Bulletin No. 2003-11

OEM No. 2003-04

## MCM Rear Engine Mount Design Change

**Original design**

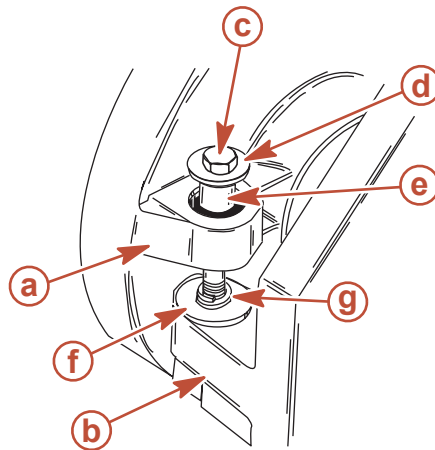
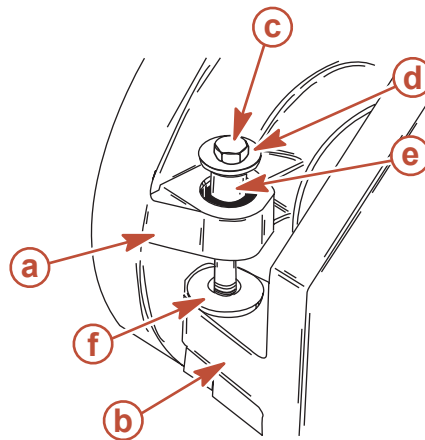
Starting with serial number 0M660000 and above, the rear engine mounts have been redesigned to improve engine alignment between the transom and the engine. With this design, the double wound lock washer has been removed and the flywheel housing engine mount has been adjusted to better align the engine coupler to the gimbal bearing.

- a** - Rear engine mount
- b** - Inner transom plate
- c** - Bolt
- d** - Washer

- e** - Spacer
- f** - Fiber washer
- g** - Double-wound washer

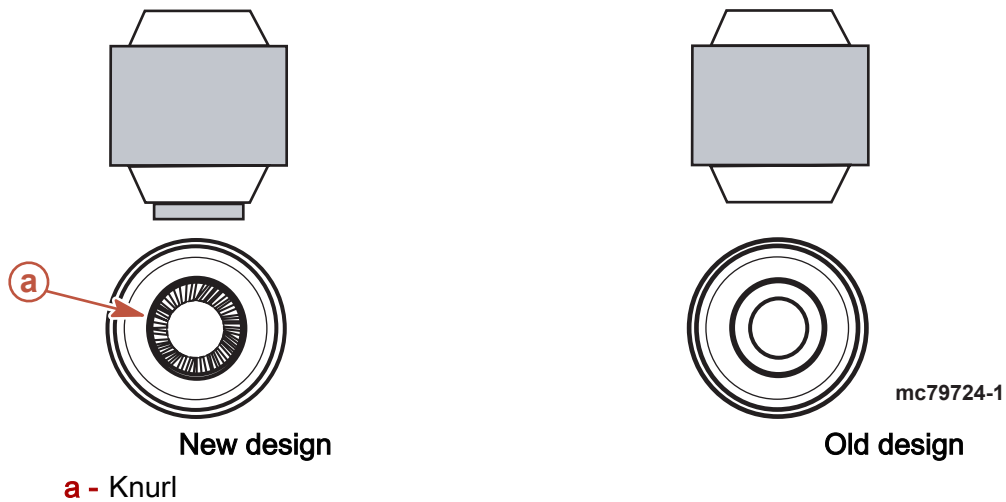
The new flywheel housing mount is serrated on the bottom side where it makes contact with the support mount ear on the inner transom plate assembly. The knurl will prevent mount windup when tightening the rear mount bolt to the nut in the inner transom plate.

mc79566-1

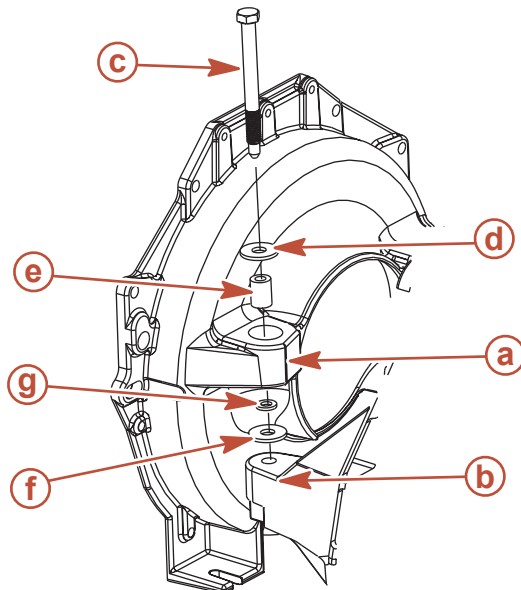
**NOTE:** *Ensure that the inner transom plate mount is clean and free of all adhesive and debris.*

1. Apply glue to the fiber washer and position it equally around the rear engine mount bolt hole on the inner transom plate mount.

2. Place the stainless steel washer inside the fiber washer.

- a - Rear engine mount
- b - Inner transom plate mount
- c - Bolt
- d - Washer
- e - Spacer
- f - Fiber washer
- g - Stainless steel washer
